Rev.	Date	By	Ckd	Description
I	17/08/2023	WN	DN	S4.56 Issue 2

30 Fairlight St, Fairlight
30 Fairlight St,
Fairlight, NSW 2094

SCHEDULE OF CHANGES

DA301
G

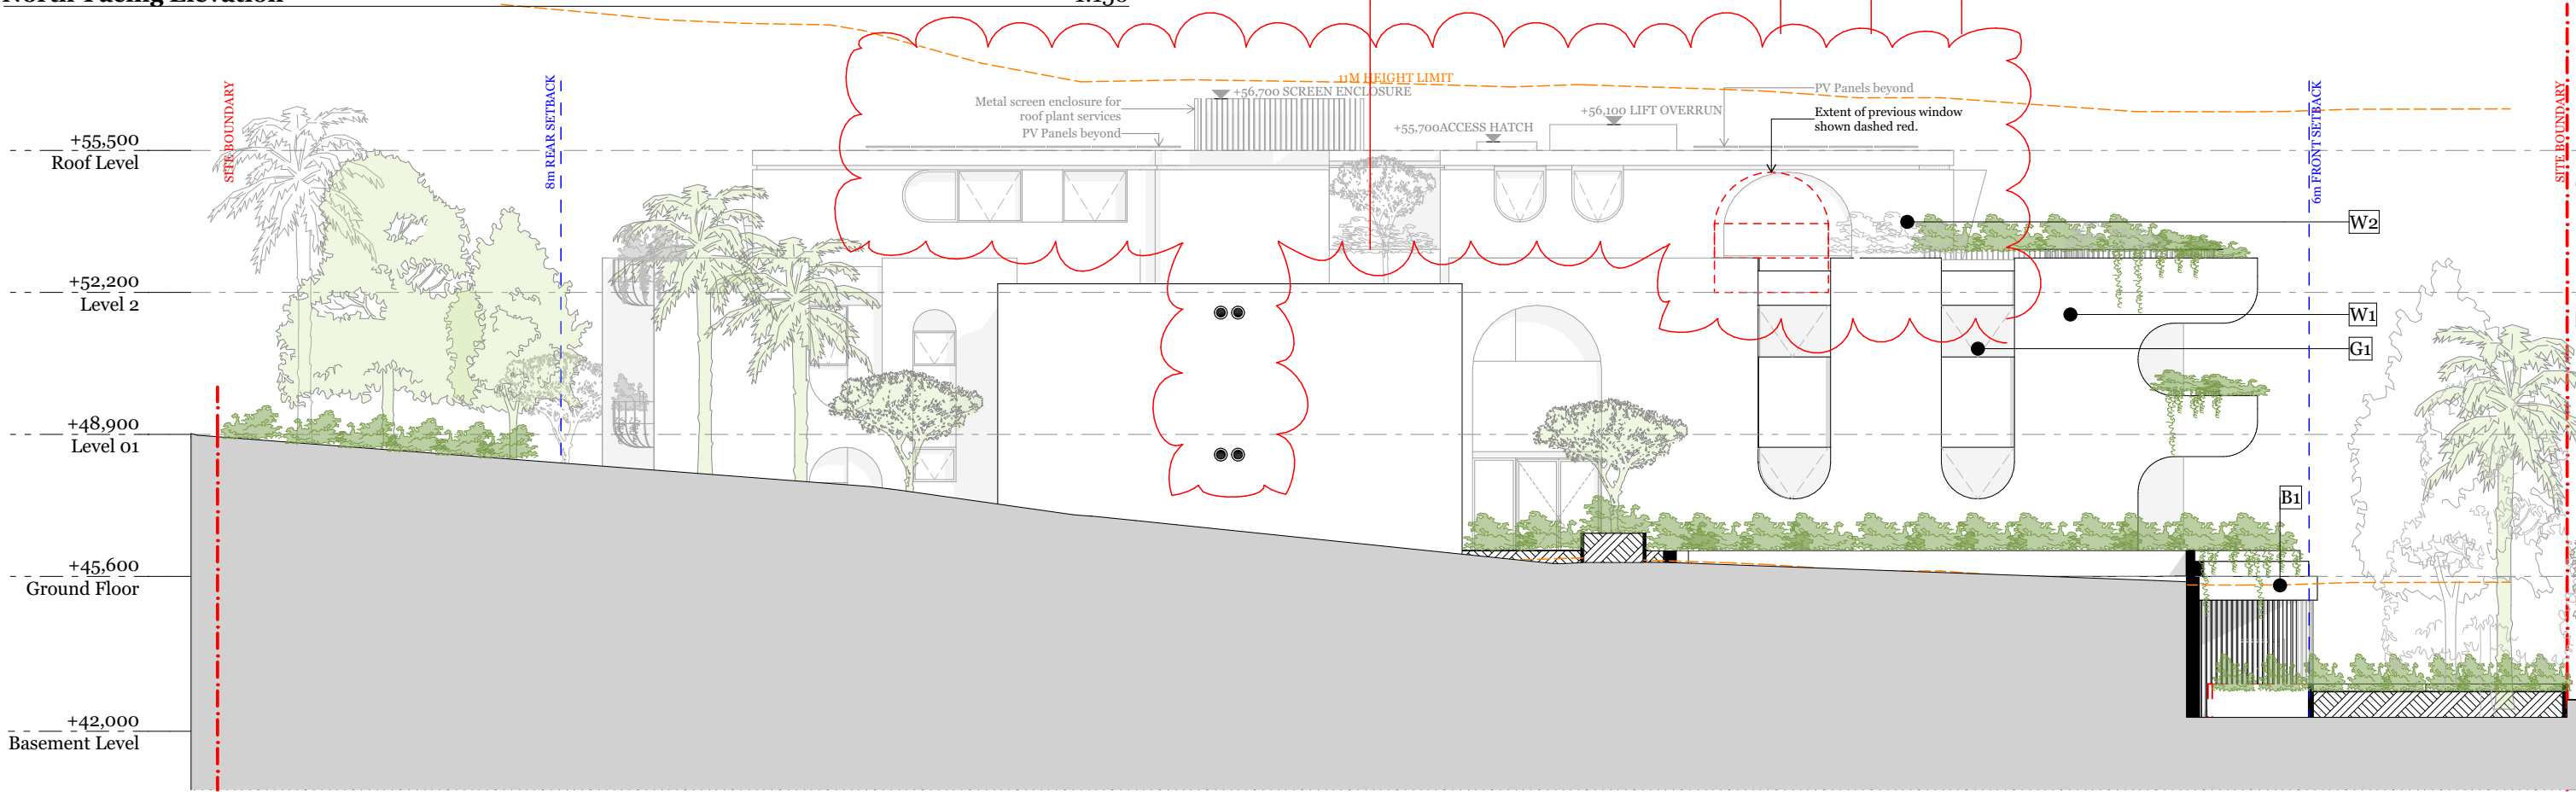
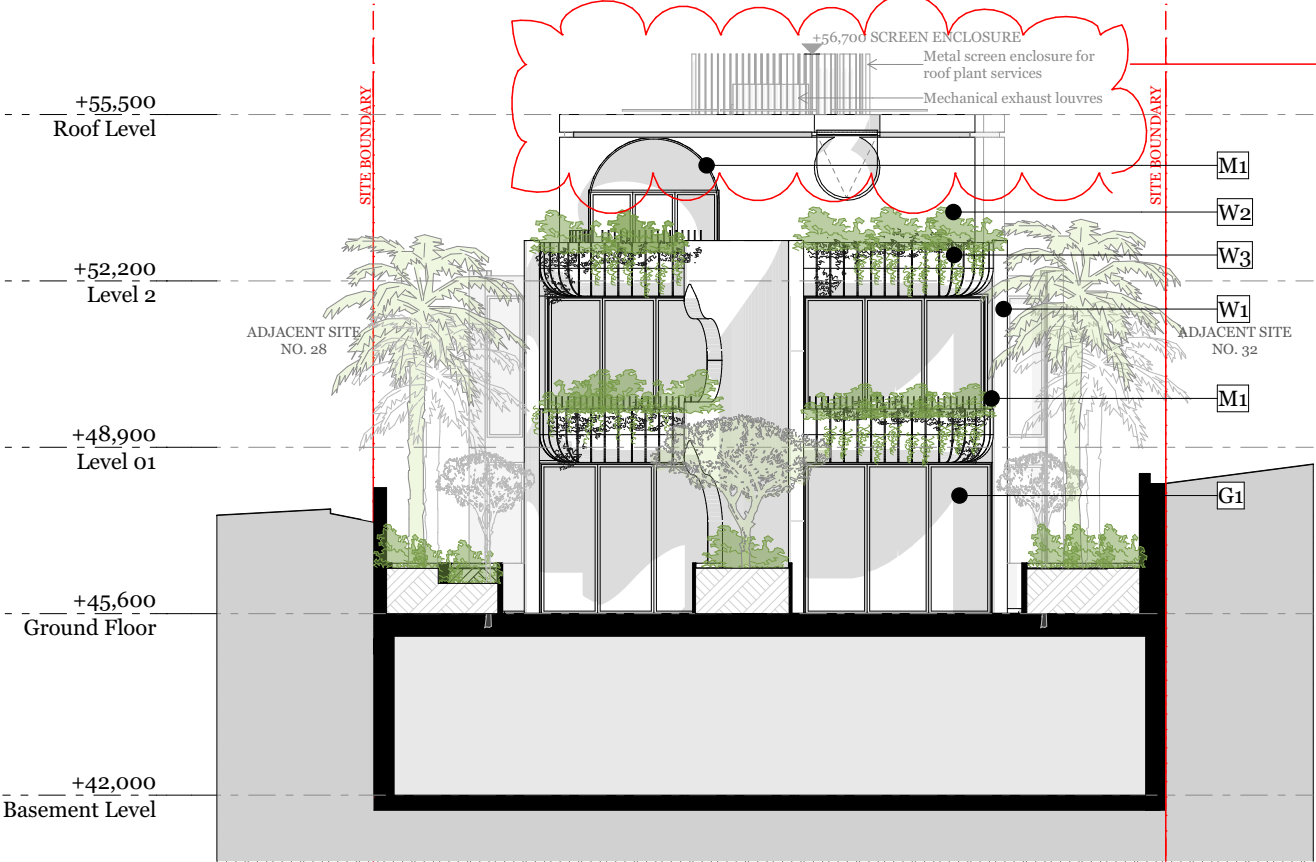
- SCHEDULE OF CHANGES**
1. Planter and deepsoil reduced to accommodate relocation of mailbox for DDA compliance.
 2. Amendment to location of carpark lobby doors
 3. OSD tank extended to accommodate minimum volume as per Stormwater Engineer's report.
 4. Additional door added for compliance as alternate fire egress with NCC D2D6.
 5. Landscaping and planter replaced with terrace hardscape to accommodate OSD tank volume below.
 6. Wall of front terrace rationalised for buildability
 7. Window opening reconfigured.
 8. Internal layout reconfigured and rationalised
 9. Plant services added onto roof including AC condensers, hot water units and mechanical vent exhausts to be concealed with metal screen enclosure
 10. PV panels added.
 11. Skylights deleted.
 12. Solid access hatch cover amended to glazed hatch.
 13. Courtyard landscape amendment.

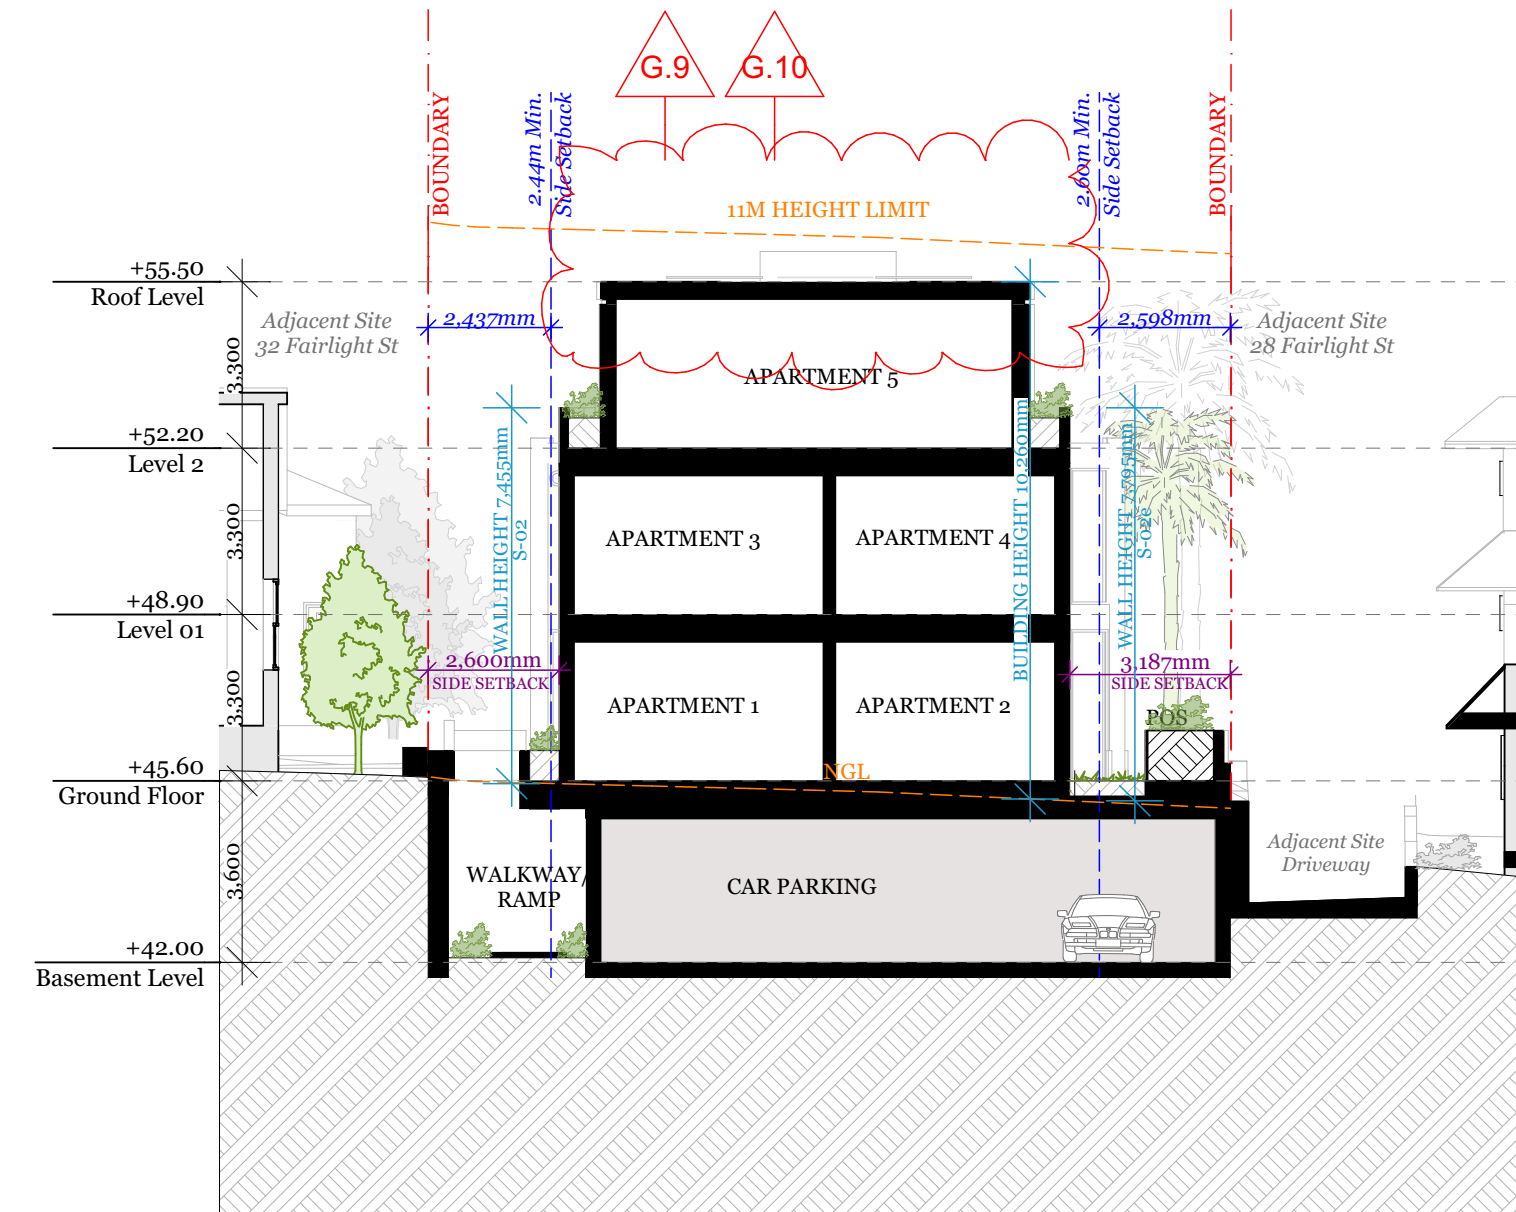
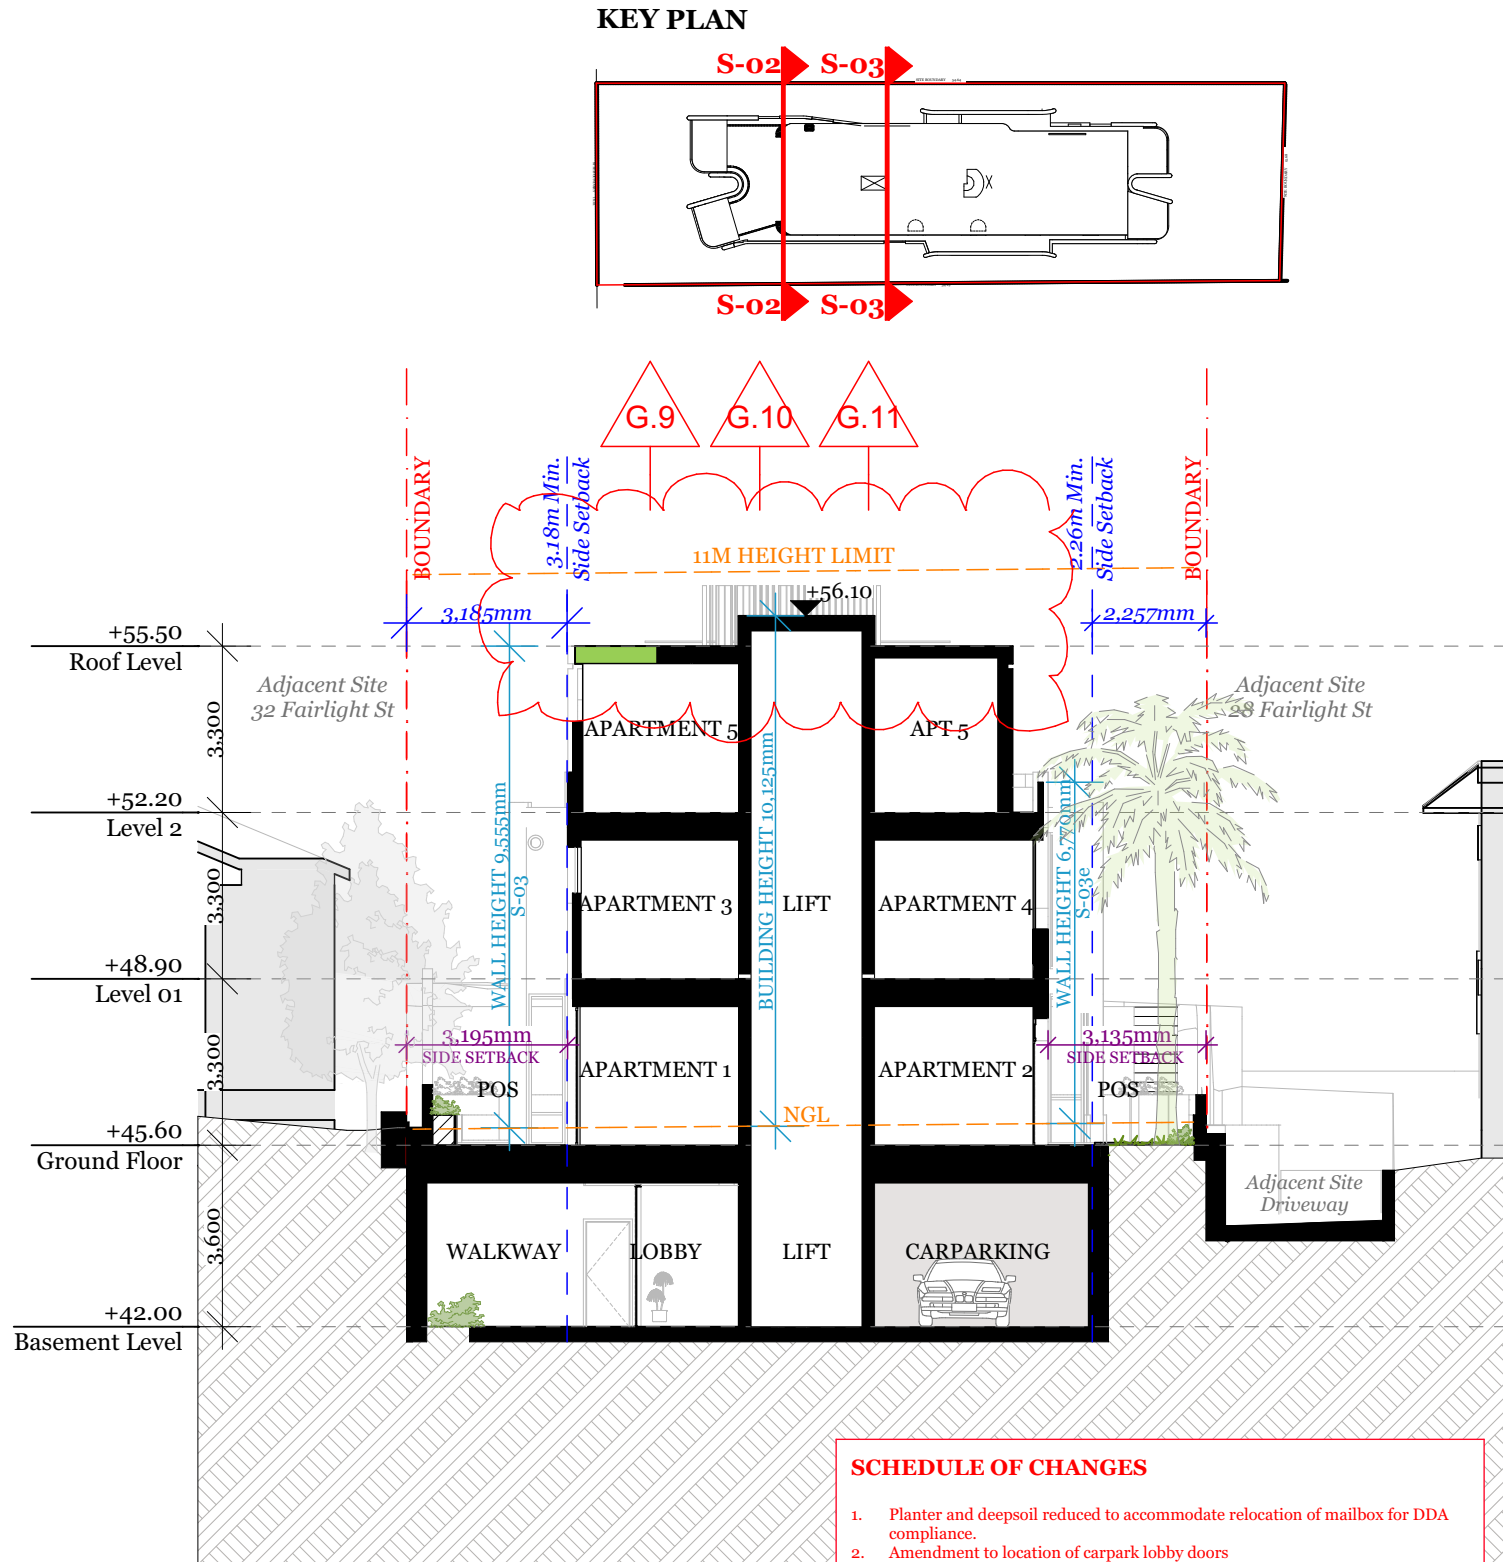
1. Planter and deepsoil reduced to accommodate relocation of mailbox for DDA compliance.
2. Amendment to location of carpark lobby doors
3. OSD tank extended to accommodate minimum volume as per Stormwater Engineer's report.
4. Additional door added for compliance as alternate fire egress with NCC D2/D6.
5. Landscaping and planter replaced with terrace hardscape to accommodate OSD tank volume below.
6. Wall of front terrace rationalised for buildability
7. Window opening reconfigured.
8. Internal layout reconfigured and rationalised
9. Plant services added onto roof including AC condensers, hot water units and mechanical vent exhausts to be concealed with metal screen enclosure
10. PV panels added.
11. Skylights deleted.
12. Solid access hatch cover amended to glazed hatch.
13. Courtyard landscape amendment.
